Comments on the Hansen Bailey report for Coalpac 'Response to PAC Review Report', with a special focus on the 'Significant Pagoda Landform'

By Dr Haydn Washington, environmental scientist, lead author of Washington and Wray (2011), peer-reviewed paper on pagodas, and Hon. Sec. of the Colo Committee, (h.washington@unsw.edu.au)

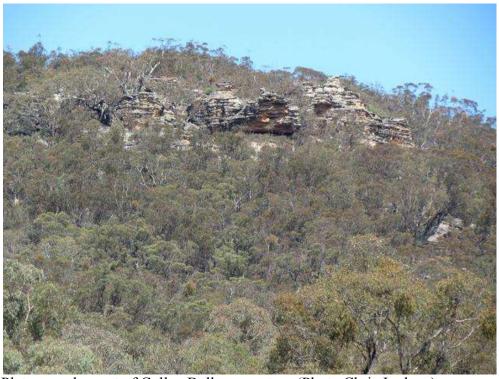
This is simply *incorrect*, and is a mis-statement of our work. As the lead author of the Washington and Wray (2011) paper I do not accept the Cumberland definition of SPL as an acceptable definition of significant pagoda landform. It is in fact not based on our paper at all. It is clearly biased to minimise the area that would be classified as SPL. Essentially, the report states that there is no SPL north of the Cullen Bullen township. Now I have visited the area in the south but not the north personally. However, even on Google Earth it is apparent that there are many pagodas in the northern part of the area, as the photos below show by those who have visited them. The above inadequate definition of Cumberland Ecology is thus being used to cut out recognition of SPL over a large part of the Coalpac project area. *I do not believe this is accurate or scientific*.
